# United States Department of the Interior

3482  
SL-051279  
(UT-065c)

Re: Minor Modification to Soldier Canyon Mine - Severe Bouncing in the Fifth North Section

SOLDIER CREEK COAL COMPANY  
SOLDIER CANYON MINE  
ROCK CANYON SEAM  
APPROVED MINE MAP  
Enclosure 1

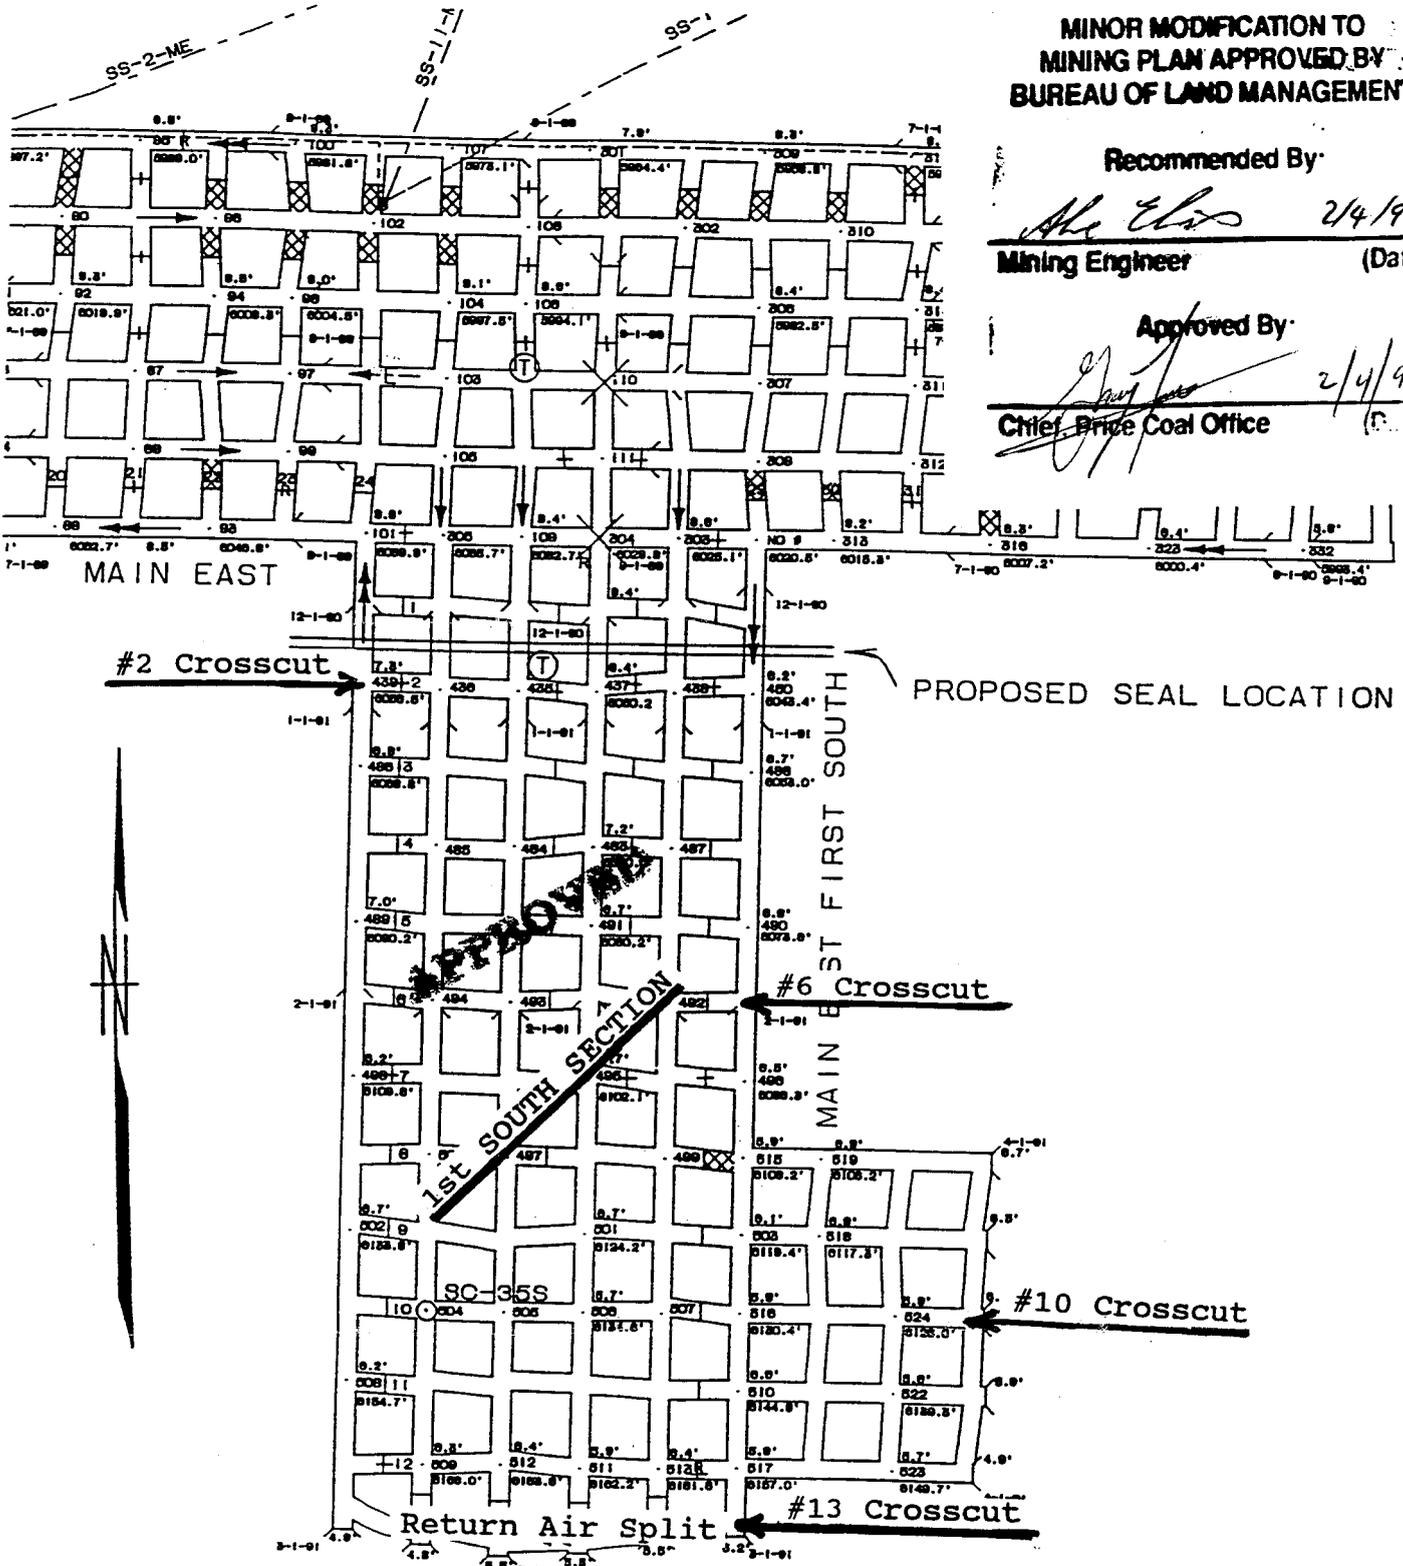
The approved mining plan was to retreat mine the 5th East area of the Rock Canyon Seam. SCCC is now proposing to: 1) stop retreat mining the 5th North section at #15 crosscut (see enclosure 1); 2) abandon the remaining coal reserves and seal the 5th East area of the Rock Canyon Seam; and 3) abandon the coal reserves and seal the 1st South section of the Sunnyside Seam (see enclosure 2).

According to SCCC, starting on January 21, 1993, the 5th North section experienced severe bouncing, which deteriorated the pillars and caused major roof failures in the entire 5th East area. Additionally, the interburden has fractured and allowed air to intermix between the two seams causing ventilation problems. SCCC and the Mine Safety and Health Administration (MSHA) officials determined that it was not safe to continue extracting the 5th East area of the Rock Canyon Seam or mining the 1st South section of the Sunnyside Seam.

BLM personnel inspected the Soldier Creek Mine on January 28, 1993. During this inspection it was noted that the 5th North section of the Rock Canyon Seam had been retreat mined to #15 crosscut. The area between the #15 and #9 crosscuts was completely deteriorated and

machinery was turned over. Evidence of pillar bursts were encountered between the #9 and #5 crosscuts. About 2 feet of rib sloughage was also seen at #4 crosscut, this was gradually reduced and changed to floor heave in the 5th East section.

Under these circumstances, the BLM has authorized SCCC to stop retreat mining the 5th North section at the #15 crosscut. This confirms the verbal approval given to Soldier Creek Mine personnel on January 28, 1993. In addition, SCCC may abandon the remaining reserves and seal the 5th East area of the Rock Canyon Seam (enclosure 1) and the 1st South section of the Sunnyside Seam (enclosure 2). An estimated 40,000 tons of coal reserves are now considered unrecoverable.
